Contract Number 008670	Contract Title I-5 Portland Avenue to Port of Tacoma Road-Northbound HOV	Federal Aid Number None
Change Order Number 201	Change Description 5-456E Storm Sewer	Date Dec 21, 2017
Region Olympic Region	Project Engineer Brenden Clarke <i>[Signature]</i>	Phone Number 360-412-3420
Prime Contractor / Design-Builder Hamilton Construction Co.

Evolution & Description Of Change

CONTRACT NO: 008670 FEDERAL AID NO:
CONTRACT TITLE: I-5, PORTLAND AVENUE TO PORT OF TACOMA ROAD - NORT
CHANGE ORDER NO: 201 5-456E STORM SEWER

15
PORTLAND AVENUE TO PORT OF TACOMA ROAD - NORTHBOUND HOV
PUYALLUP RIVER BRIDGE NO. 5/456E
BRIDGE DRAINS DETAILS 1

BRIDGE SHEET NO. BG172B
SHEET 1028B OF 1255 SHEETS

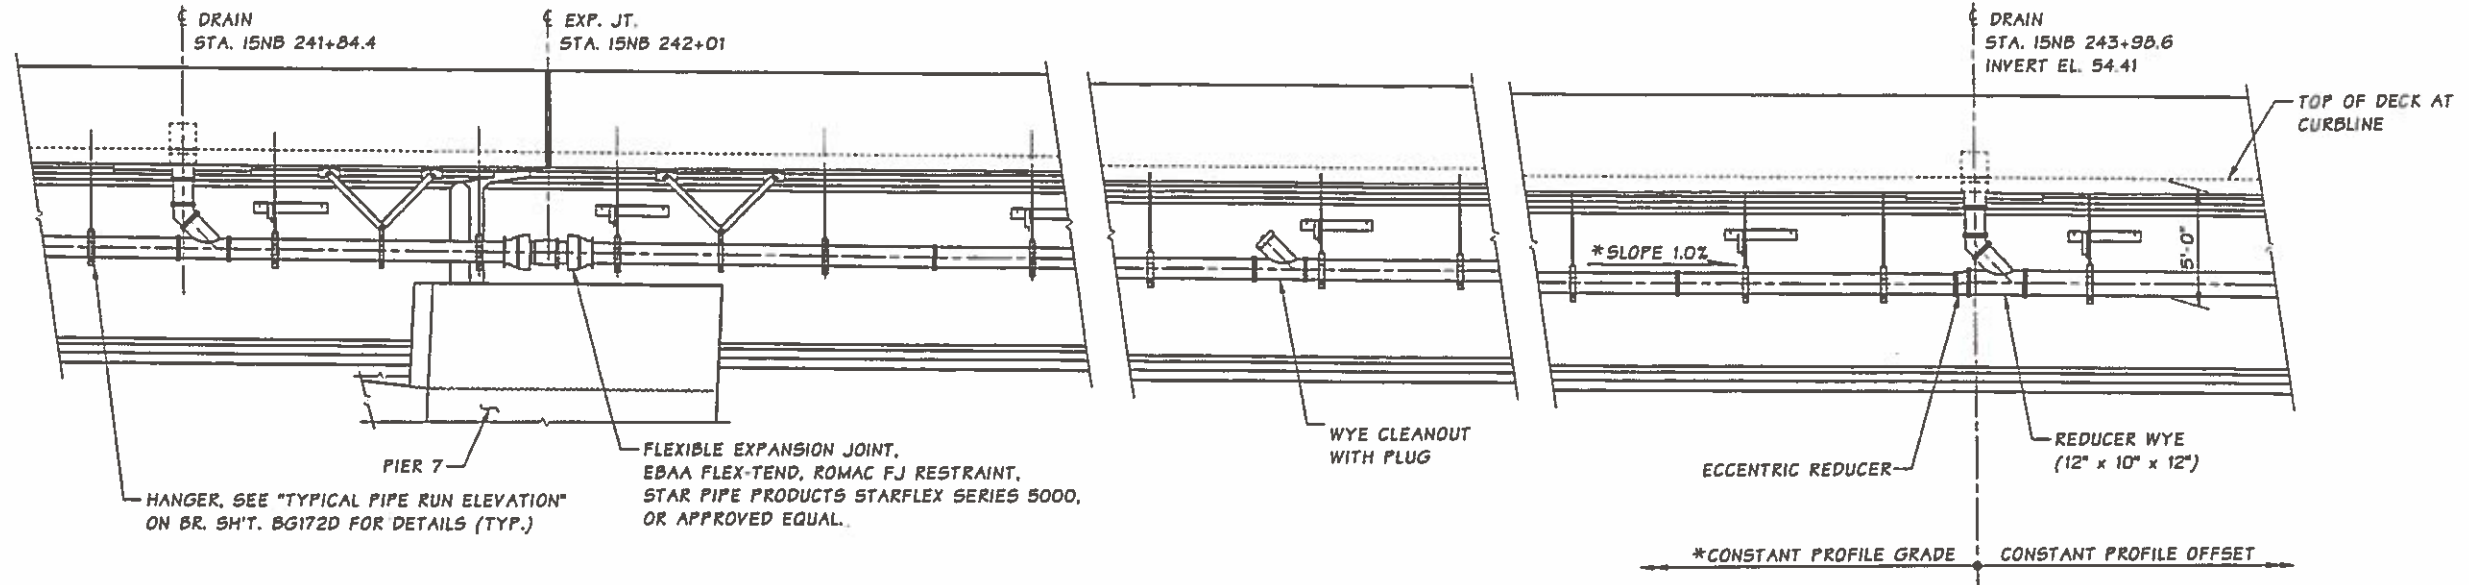
The Work consists of modifying the wing wall on Pier 7 of bridge 5-456E as shown on page 4 of this change order modifying the crossbeams of Piers 5, 6, 8, and 9; and constructing storm sewer lines as shown on pages 5 through 13 of this change order and connecting to the drainage structure noted as DR5B-49. The work includes engineering, surveying, painting pipe, anchors, hangers, restraints, excavation and backfill, furnishing and installing storm sewer pipe and appurtenances. Plan sheet BG78 (935) is replaced with page 4 of this change order. Plan sheets BG172B (1028B) through BG172J (1028J) are added to the Contract with pages 5 through 13 of this change order.
